**Stormwater Management/BMP Facilities
Record Drawing/Construction Certification
Review Tracking Form**

County Plan No.: SP-66-99
 Project Name: S.A. Seaman Concrete (SKIFFES CREEK/NORFOLK PARK)
 Stormwater Management Facility: Dry Det w/ Infiltration

Re: S. A. Seaman Concrete (Skiffes Creek Industrial Park)
County Plan SP-66-99; Infiltration Basin
County BMP ID Code: ~~JR 050~~ SC 007

ENVIRONMENTAL DIVISION REVIEW COMMENTS
SEAMAN CONCRETE CONSTRUCTION, INC.
WAREHOUSE/STORAGE FACILITY
PLAN NO. SP-66-99
June 16, 1999 MCE/DEC

S.A. SEAMAN CONCRETE CONSTRUCTION CO. INC.
 INFILTRATION POND RECORD DRAWING

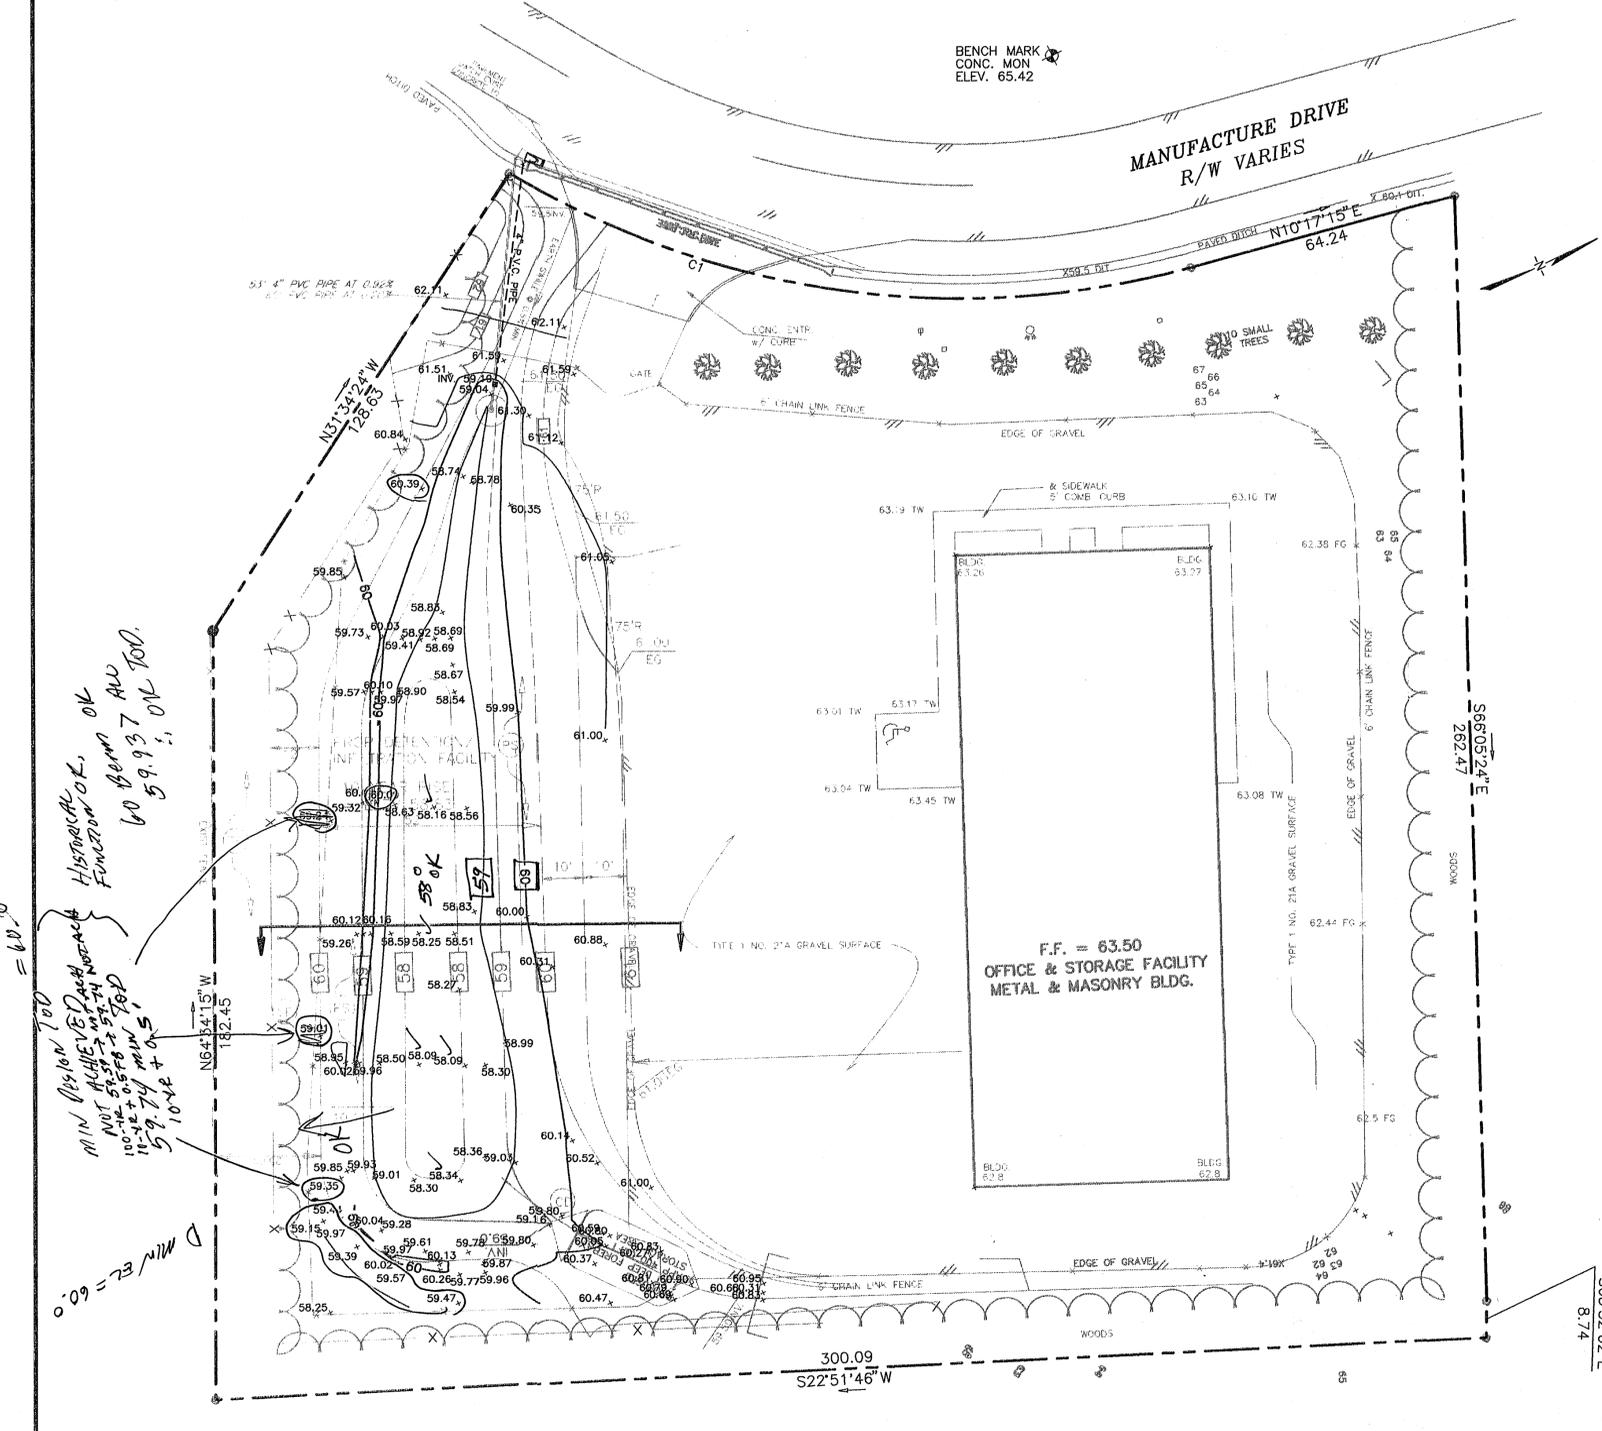
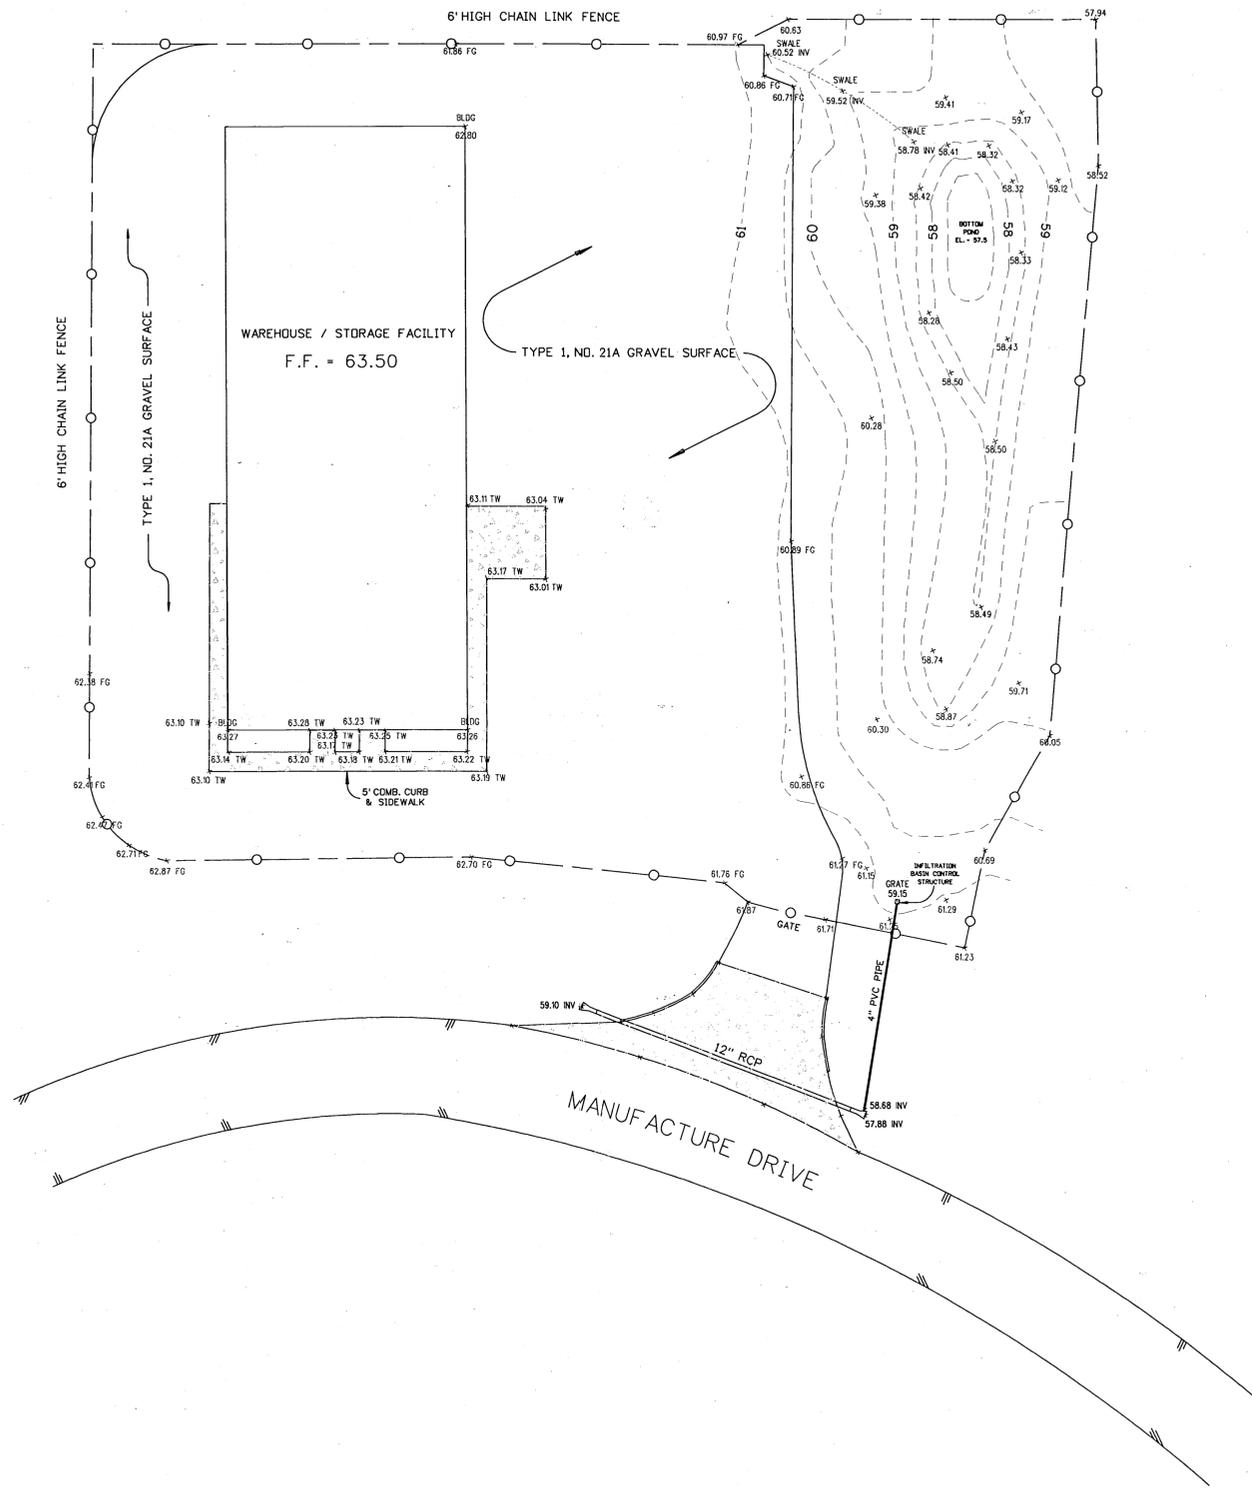
10-YR 59.24
 100-YR 59.59
 R.O.P.B. 59.24+0.5=59.74
 1. 100-YR 59.59 NOT ACHIEVED.
 2. 10-YR + 0.5' F.B. 59.74 NOT ACHIEVED.
 3. 10-YR 59.24 < 59.0 NOT ACHIEVED.

-NO CC.
 -NO MAINT PLAN.

HISTORICAL, OK
 60 BEMD ALL
 59.97, OK TOO.

MIN DESIGN 100
 NOT ACHIEVED DATA
 100-YR + 0.5' F.B. 59.74
 11-YR + 0.5' F.B. 59.74
 5-YR + 0.5' F.B. 59.74
 10-YR + 0.5' F.B. 59.74

1. In accordance with the Note # 19 on Sheet C-3 of the approved plan, construction certification for the stormwater management/BMP facility is required. None was provided. This is especially important since the BMP is an infiltration type facility and it has a small engineered and compacted earthen embankment along the south side. The certification can be in letter format or by use of the certification statement in Section 4 of the JCC, Stormwater Management/BMP Facilities, Record Drawing and Construction Certification, Standard Forms & Instructions. *(Note: The construction certification shall be by a professional engineer who inspected the structure during it's construction.)*

3. The record drawing dated October 10th 2001 is **satisfactory**. Please forward one reproducible and one additional blue/black copy of the record drawing to our office.
